**ADSC/WSDOT Joint Meeting**  
November 20, 2020, 8:30 A.M. – 11:30 A.M.  
**ADSC/WSDOT Sign-In Form**

## 3. I-90 Cabin Creek to W Easton – Phase 3 Constructability Review Jeff Minnick

## 5. Marsh Road Constructability Review

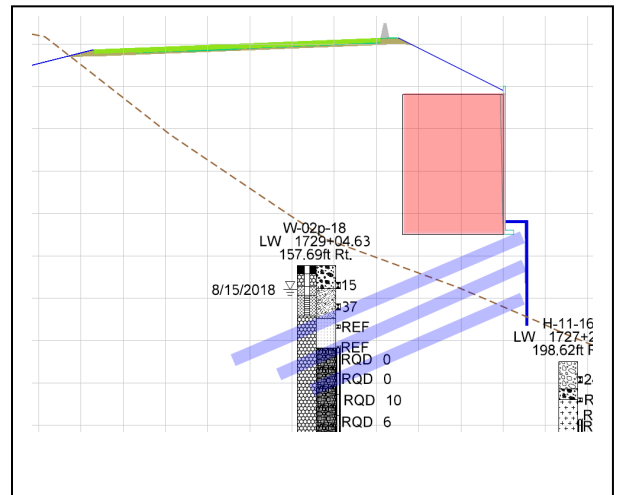
**Q: For the PGAs, how would you get the top two rows of PGAs installed?**

**Q: Would you be able stress these PGAs from the front?**

**Q: The profile of the working bench will be at about 14%. How steep of a profile can the contractors work from, and how steep of a profile can you traverse for access?**

A: Lance Rasband– you can do this several ways. Drill them from the back of the slope before backfilling, or you can do it in sequence while you backfill. You may need a crane supported platform.

A: Doug Watt – asked if the wall could be designed to be backfilled to a level above the pocket and then the anchor could be installed using excavator mounted drill parked on the backfill and reaching over the top.

A: Andrew Fiske stated we are planning to build a 30 to 50 ft tall MSE wall on top of the wall, so he thought that Doug's method could be feasible, but the design would need to be checked.

A: Jim Cuthbertson pointed out that the soldier pile itself would be sticking up and might interfere with the drill. You would need something that was articulated to get the right alignment. In response to this Doug stated that he would probably install the first couple of anchors from the bench on the front side of the wall as that has the best access. To this end, Jim asked how high up can a conventional drill reach; from the bench surface to where? The consensus was about 8 ft vertical. If the pockets were laid out right you could dig down below the bench and get the first one, backfill back to bench grade to get the second, then place a bit of fill and get the third. Ryan Thody also thought that you could probably install the first two rows from the front of the wall.

A: Jim Brunkhorst raised the issue of lock off load. Large lock-off could yard the pile around with limited backfill.

A: Andrew Byrd stated that they were thinking there would need to be multiple tensioning cycles. As more load is applied by backfill and more MSE wall is built on top, anchor tension might need to be increased incrementally to control deflection.

A: There was discussion about constructing the anchors for a fill wall. Should you install anchors first and fill around them or do you fill first then install through the fill. There are design and constructability issues with either option. Tony Allen wanted to discuss the design concept more with his staff and the project office.

A: Lance Rasband mentioned that if anchors are going to be retensioned, he prefers bar anchors rather than strand. Each wedge setting on strands nicks the strands slightly and premature failure can happen on strands when set and reset too many times, depending on loads, but strand anchors are easier to handle. Anchor lengths of 80-90 ft for the top row and 70-ish for the lower are anticipated. Bar anchors would need couplers.

A: Greg Radom asked about the soils and rock conditions as that drives the size of the equipment. He also asked about moving the access bench from the front side of the soldier pile wall to the back side. The project office did not want to do this as it would greatly increase the excavation quantity or require temporary shoring.

A: Ryan Thody stated that most drills can traverse 15-degree slopes, but they like to drill on slopes no steeper than 5-degrees. (Note taker comment: I think when Ryan said degrees he may have intended percent.) They could use cribbing or something at each pile location to level the rig if the slope isn't too steep to start with. This is for both soldier pile drilling and anchors. It was mentioned that shotcreters would probably bring in scaffolding to work from, so the 15% grade would probably work for them.

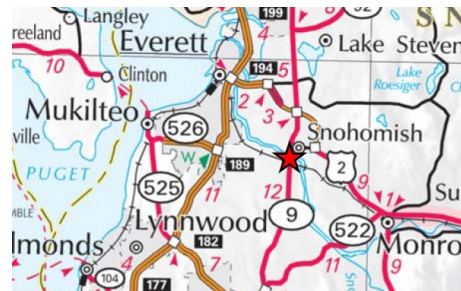
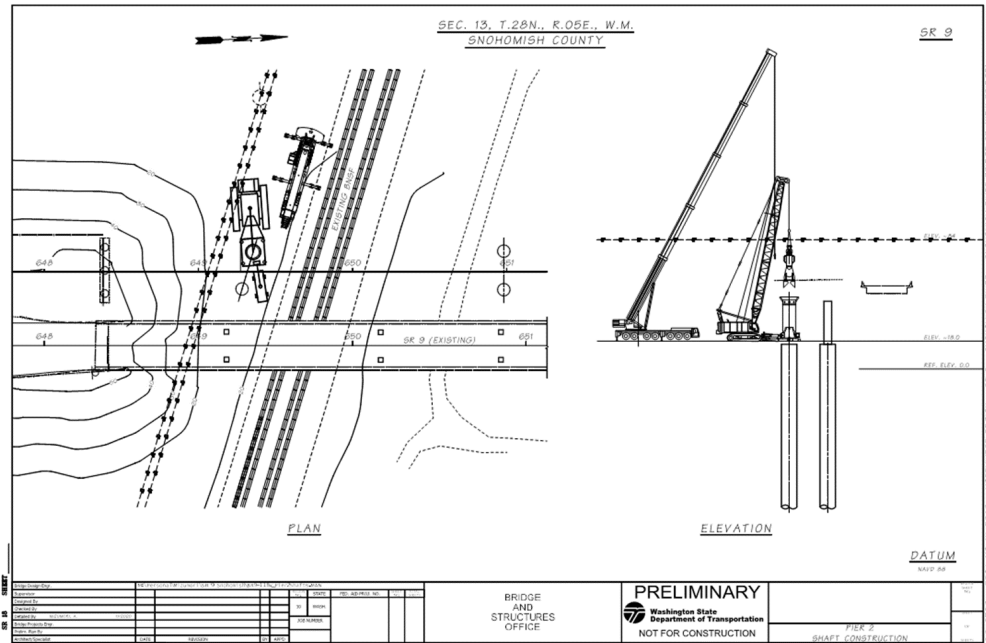
**Q: Clearance needed for work?**

**Q: Other constraints; useful techniques?**

A: Ryan Thody stated that power line clearance depends on voltage. Usually, 10 ft clear for less than 50 kv but 250 kv can be 20 ft or more clear. OSHA has requirements for clear space depending on voltage. Greg Radom stated that power companies also have their own specific requirements. You need to check with the utility.

A: Amy Leland stated there may be an opportunity to de-energize the lines, and asked if that would enable work in the 10 to 15 ft range. Lance Rasband stated that even de-energized that would be the minimum.

A: Amy Leland asked the group if they thought piles or shafts would be better based on the soil conditions and anticipated shaft lengths. Doug Watt thought that piles might be the better option based on cost. With the OH power, low clearance equipment may be needed and there could be a need to splice shaft casings, but that may be needed just because of the shaft length of 200 ft anyway. The railroad may also have constraints with working next to the track.
